**FINAL DRAINAGE REPORT
FOR
PLATTE SELF STORAGE
COLORADO SPRINGS, COLORADO**

MAY 2024

Please include project No.
PPR2418

FOR REFERENCE ONLY
NOT FOR CONSTRUCTION

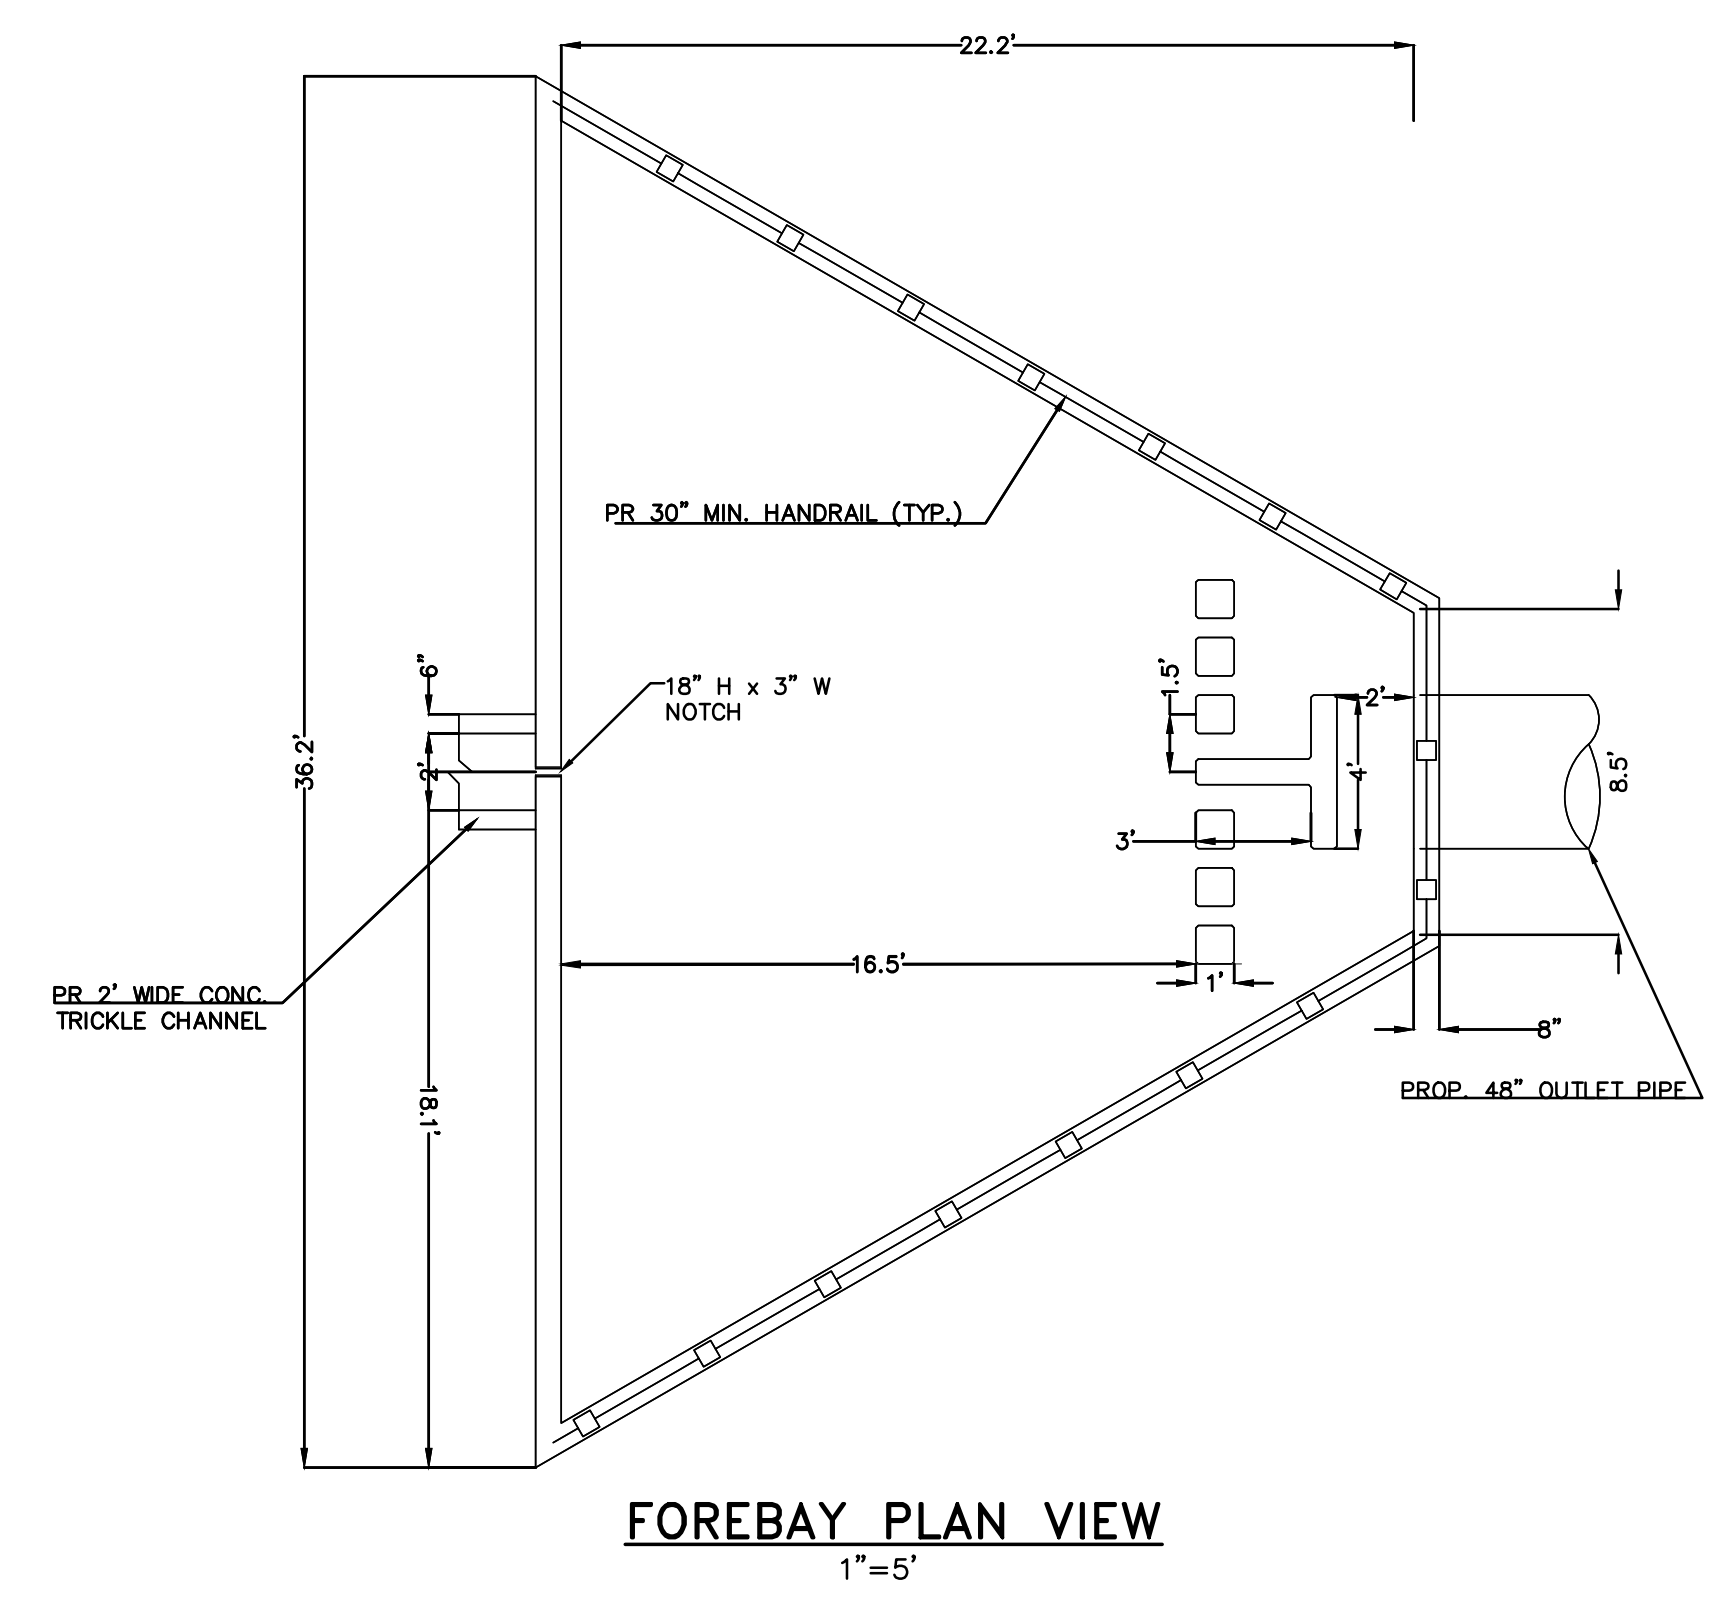
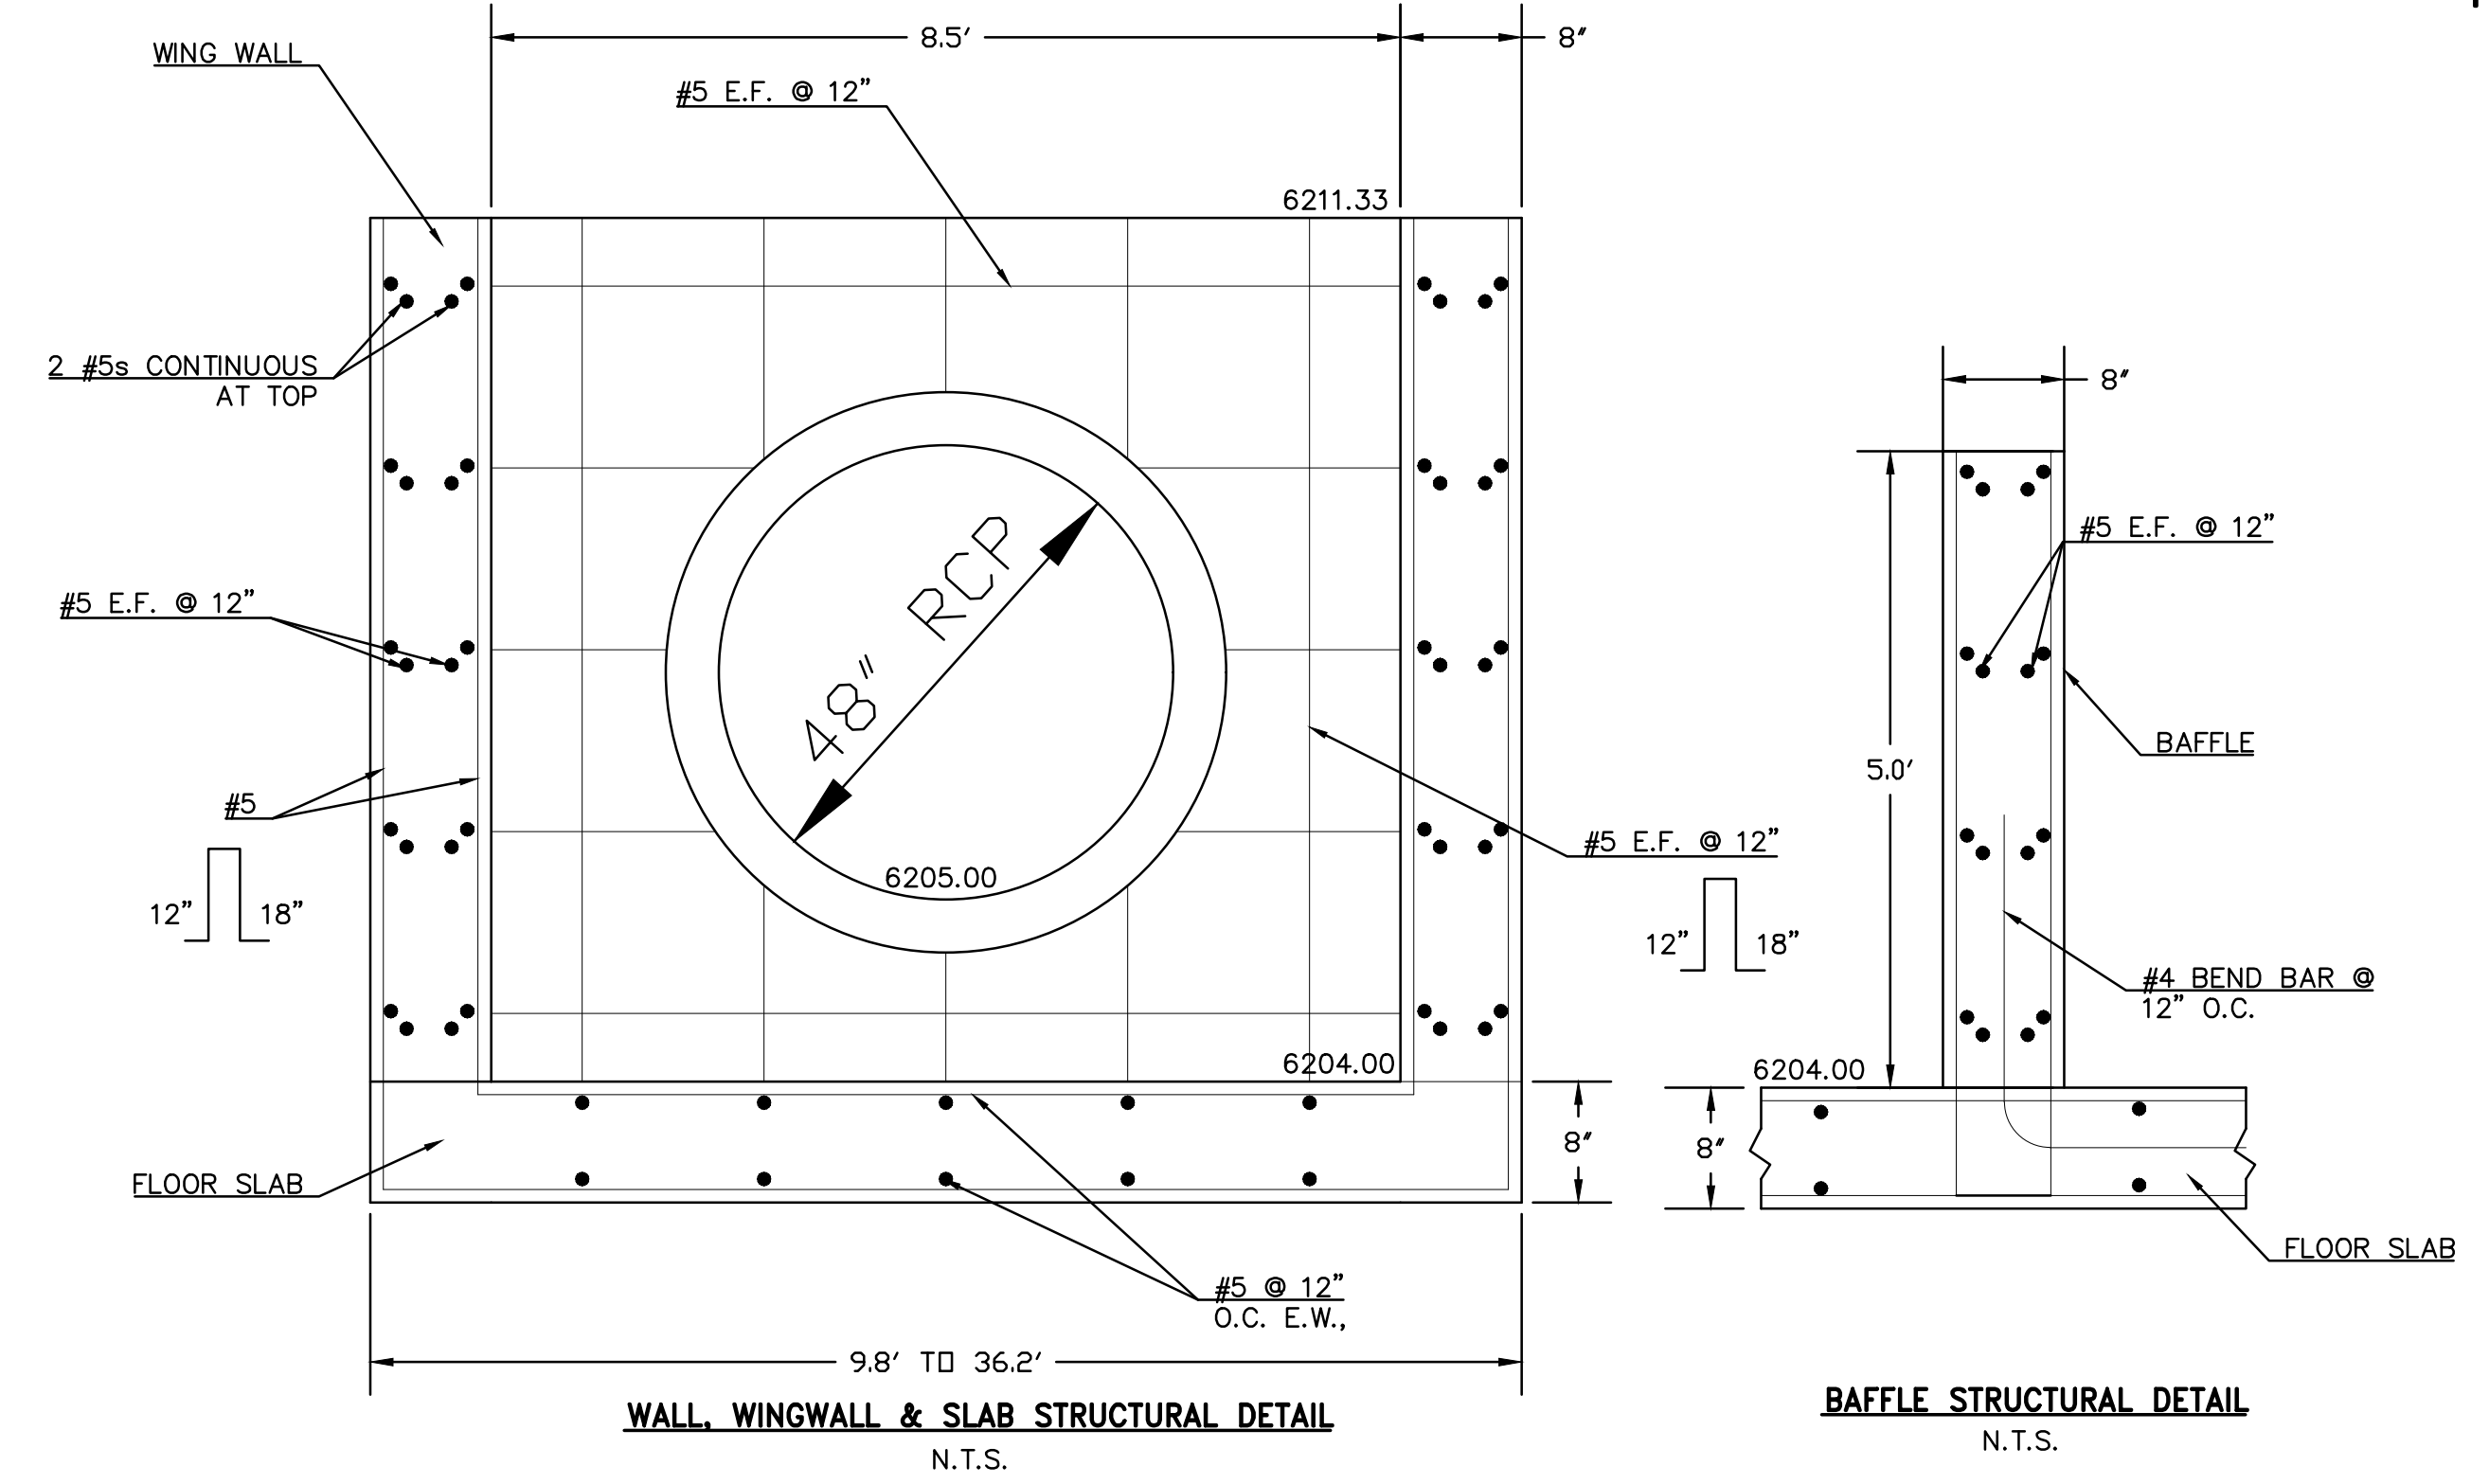
Construction plans are not reviewed within the drainage report. Please remove.
